**PROJECT SITE** MAXIMUM DEVELOPMENT POTENTIAL WITH OPTION #4 OVERLAY EVOLUTION OF BMB CONNECTION + COURTYARDS EVOLUTION OF THE COURTYARDS ACCESS TO DAYLIGHT PERSPECTIVE COURTYARD VIEW + INSPIRATION IMAGES

900, 912, 1130 RAINIER AVE. S. SEATTLE, WA 98114

EARLY DESIGN GUIDANCE #2 SDCI # 3036456-EG NOVEMBER 25, 2020

#### **ADMINISTRATIVE EDG #2 REVIEW COMMENTS:**

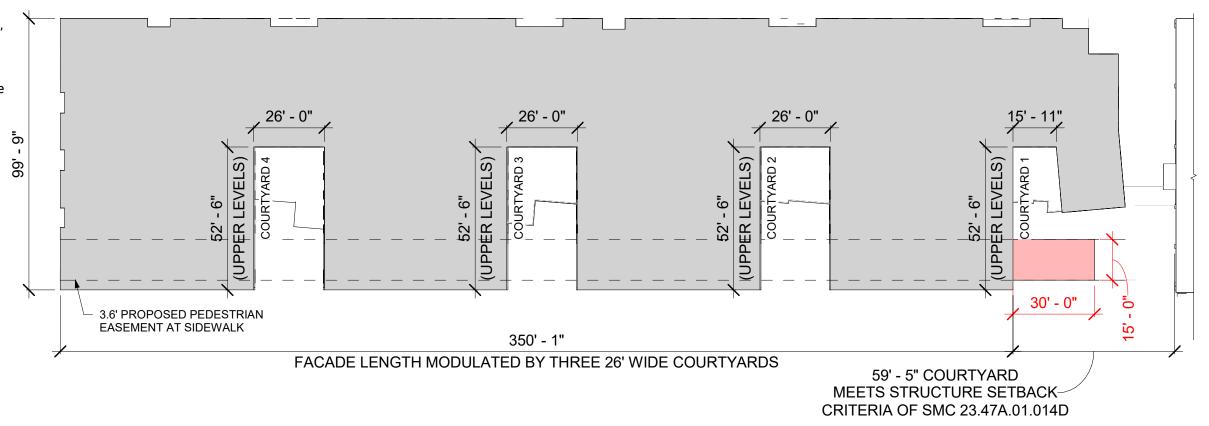
Staff does not support this departure at this time. Based on the proposed building height and the guidance provided herein, the minimum setback distance appears necessary in order to create courtyards that are scaled appropriately to the building height. If this departure is proposed at EDG2, the packet should include diagrams showing that the street-facing façade is sufficiently modulated and that the modulations effectively create usable courtyards spaces that are consistent with applicable design guidelines. (CS2-C-3. Full Block Sites, Central Area PL1-2 Connection Back to the Community, Central Area PL3-2-h. Comfortable Pedestrian Environment, DC2-D-1. Human Scale, Central Area DC3-1-c. Common Open Space).

The landscape and architectural plans clarify design intent toward creating comfortable, safe spaces for the public at street level courtyard areas (PL1-2, PL2-2-h) and private residential courtyard refuge areas. Design elements creating a human scale at these courtyards demonstrates that they meet the intent of DC2-D-1, DC3-1-c guidelines with emphasis on courtyard "usability" and relationship to the urban realm. (CS2-C-3)

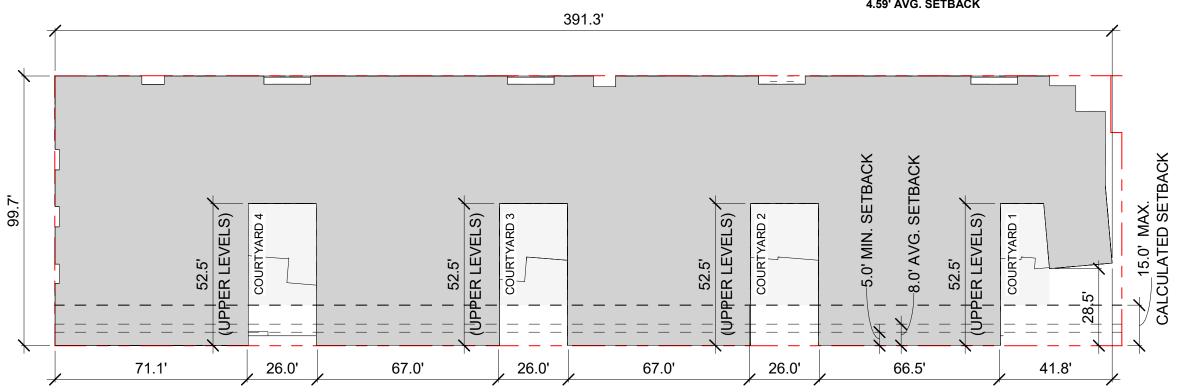
Staff does not support this departure at this time. The current design does not provide a sufficient design rationale for this departure. If this departure is requested at EDG2, the packet will need to show that the guidance above has been met related to appropriately-scaled courtyard spaces and the massing responses to the zone transition to the east and landmark transition to the south. Additionally, the packet should provide a clear design-guideline based rationale that the additional height improves the building design and relationship to the Rainier Ave. S. street frontage. (CS2-C-3. Full Block Sites, Central Area PL1-2 Connection Back to the Community. Central Area PL3-2-h. Comfortable Pedestrian Environment, DC2-D-1. Human Scale, Central Area DC3-1-c. Common Open Space).

The pedestrian oriented, human scale design approach of each courtyard is a more successful response than an additional 3' rooftop setback that meets the zoning envelope.

The street level courtyard renderings on pages 56 and 57 demonstrate how pedestrians, visitors, and building residents alike will be able to physically interact with the added area at the street level the courtyards provide. The full zoning 8' setback at L8 will have very little impact at the pedestrian level compared to the project proposal.

The EDG2 response submittal illustrates this with a transparent box around our preferred scheme and shows a step by step erosion to get to our solution. The transparent box shows exactly the mass that is allowed on pages 27 (with no departures).

#### **EAST ELEVATION DEVELOPMENT:**

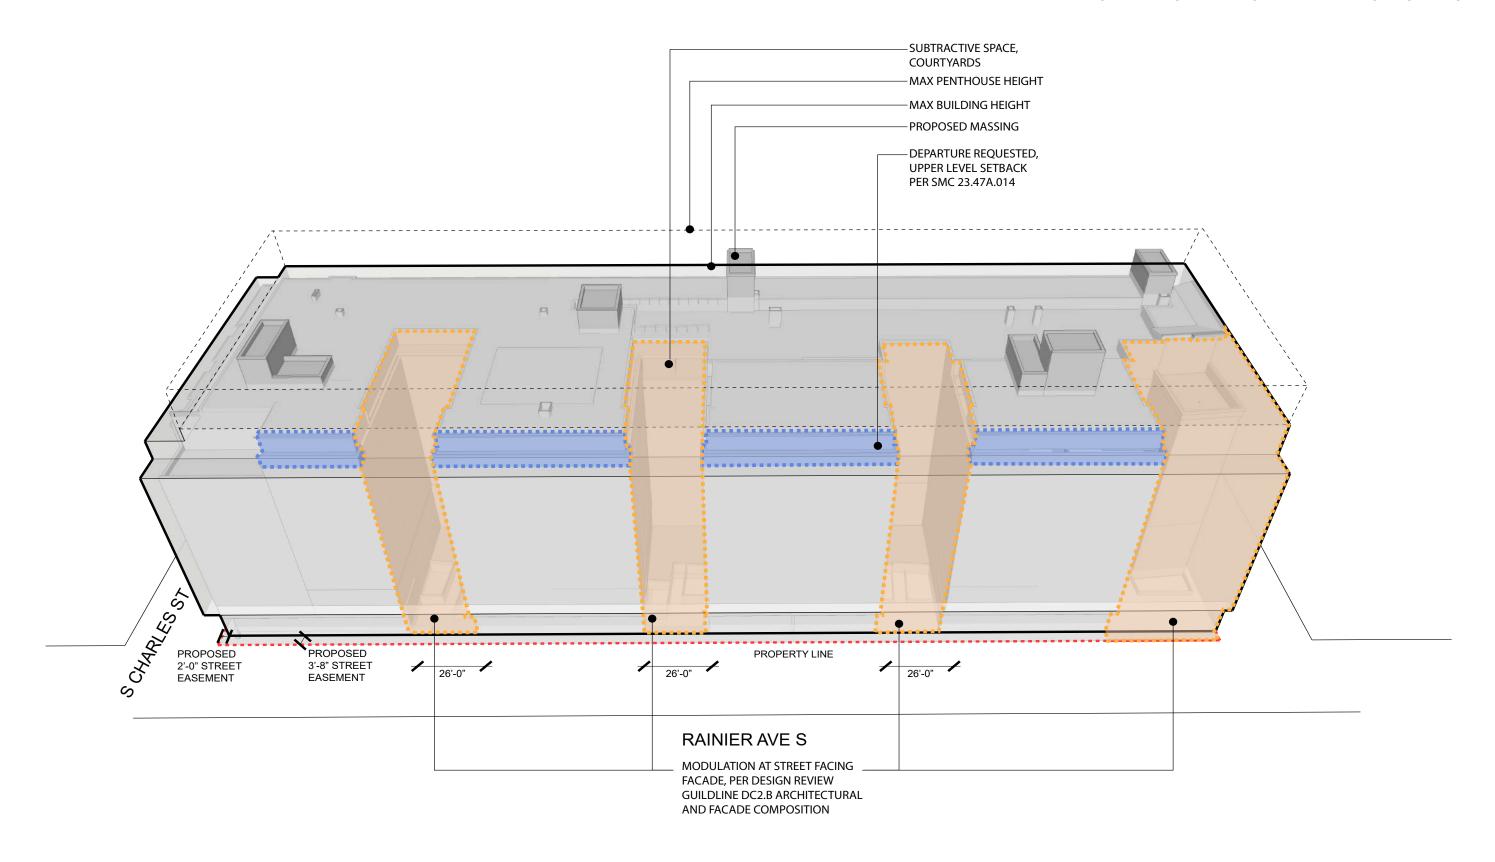
ii. Zone Transition Massing Response. The massing design shows a minimal massing transition to the height of current and permitted building height to the east (Central Area CS2-1-b. Transition and Delineation of Zones, CS2-D-3. Zone Transitions).

Since EDG#1, the east facade has been further articulated in response to the minor zone transition of 20' in height on the east edge. This is represented as Option #4. Option #4 is consistent with the design guidelines that encourage facade modulation and roof line articulation to transition scale. The project site is not adjacent to a single-family zone. It is immediately adjacent to a NC 3-55 (M) zone to the east, which is then adjacent to a LR2 (M) zone further east. The proposed project is significantly downslope from lower density zones. Given this context, the design response is appropriate.

NOTE: THE PROPOSED OPTION #4 MASSING PROPOSES MORE MODULATION THAN IS REQUIRED BY ZONING

**EVOLUTION OF THE COURTYARDS**

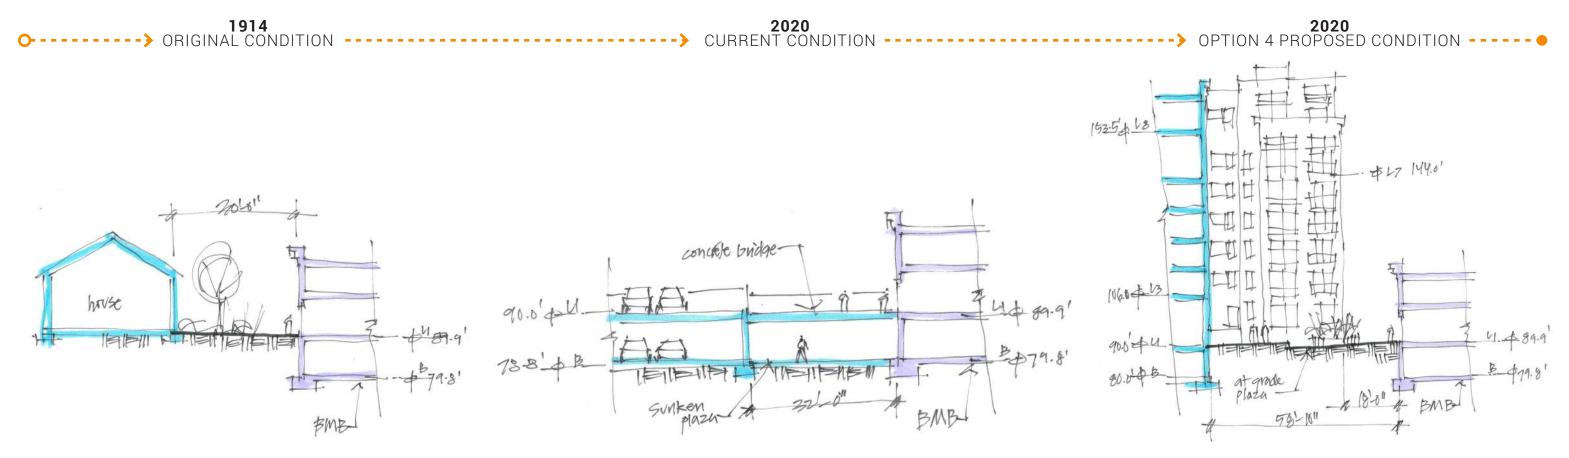
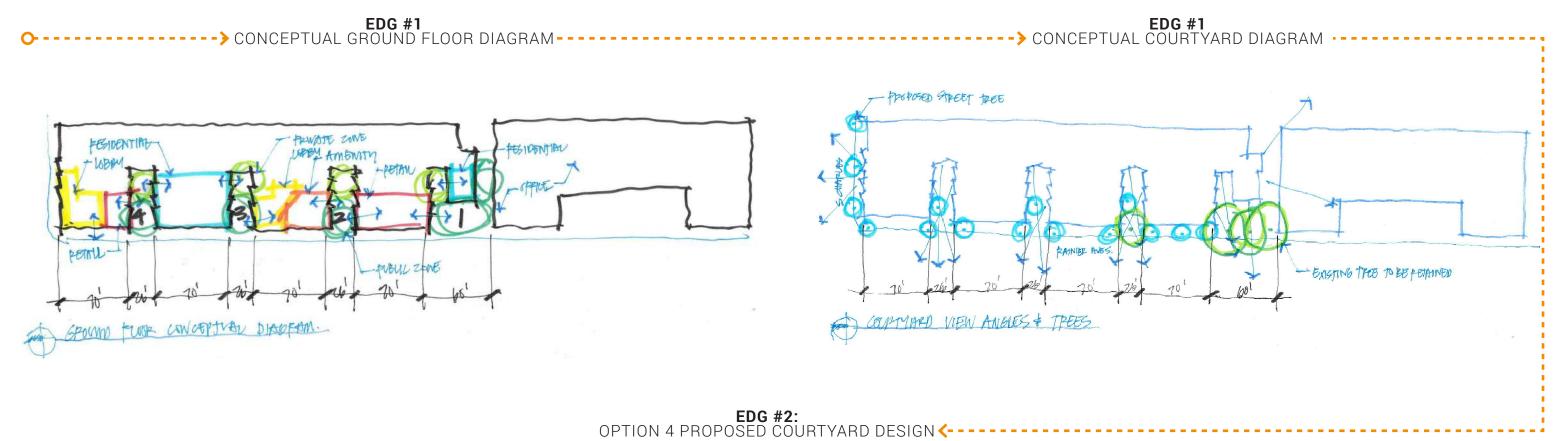
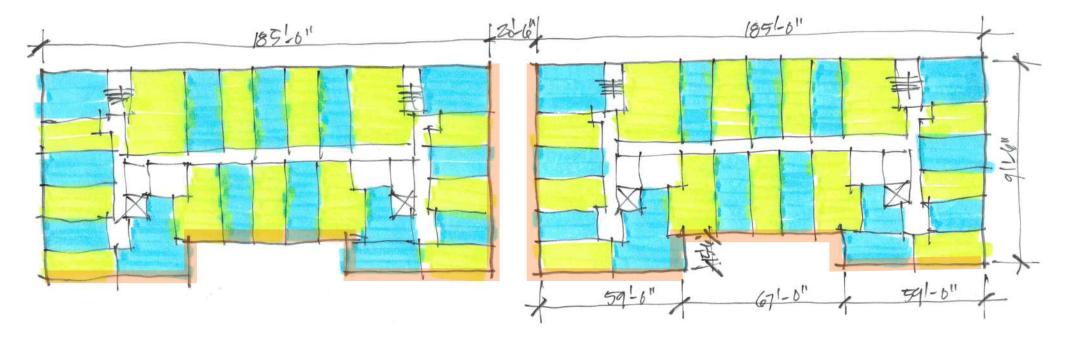
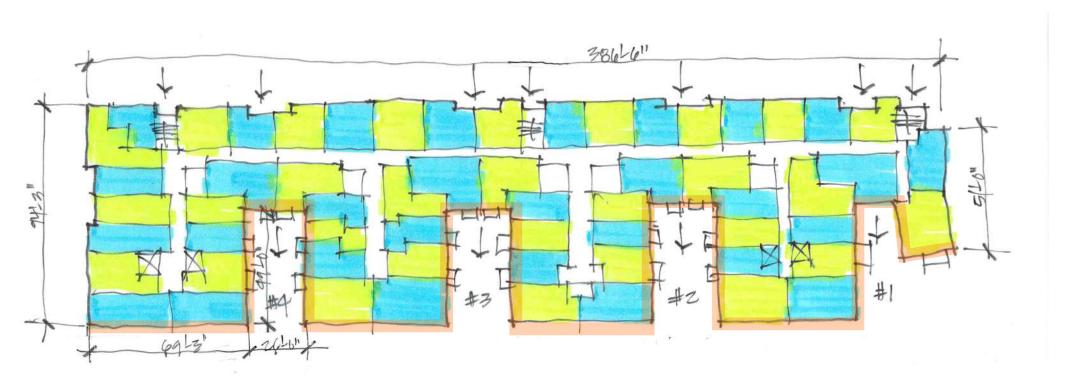
Although Option 3 has strengths in its conceptual street frontage design, the overall massing lacks sufficient massing response to the following elements: i. Street Frontages and Courtyard. The massing of Option 3 includes minimal use of secondary massing elements to aid in the visual reduction of building scale and to provide human-scaled elements along street frontages and courtyards. Courtyard dimensions are narrow in relation to the building height and for use as spaces for congregation (Central Area PL3-2-h. Comfortable Pedestrian Environment, DC2-D-1. Human Scale, Central Area DC3-1-c. Common Open Space).

a. Enlarge courtyard dimensions and incorporate upper-floor setbacks with the inclusion of secondary massing elements to improve the relationship of the courtyard spaces to human scale. Include additional study in the design packet to show that the proposed massing results in functional courtyards that meet the intent of the design guidelines. Staff notes that the outdoor spaces of Option A, have more generous proportions that appear to be more appropriate with the building height (Central Area PL3-2-g. Voluntary Spaces, DC2-A-2. Reducing Perceived Mass, DC2-D-1. Human Scale, Central Area DC3-1-c. Common Open Space).

#1 We have modified the courtyards to: remove the canted bays, widen the courtyards and reduce the depth from east to west, and added balconies and other elements that help humanize the space.

#2 The revised EDG submittal clarifies the public and private areas of the courtyard, separated by landscaped bio-retention planters and a raised partial level. The public courtyard areas are located at street level, expanding the public active space, and connecting it to the retail and building amenity spaces. This approach serves to clean roof runoff, provide a softening of the urban realm and demarcate private, semi private and public spaces.

OPTION 4 HAS A 24% INCREASE OF PERIMETER WALL ACCESS TO LIGHT
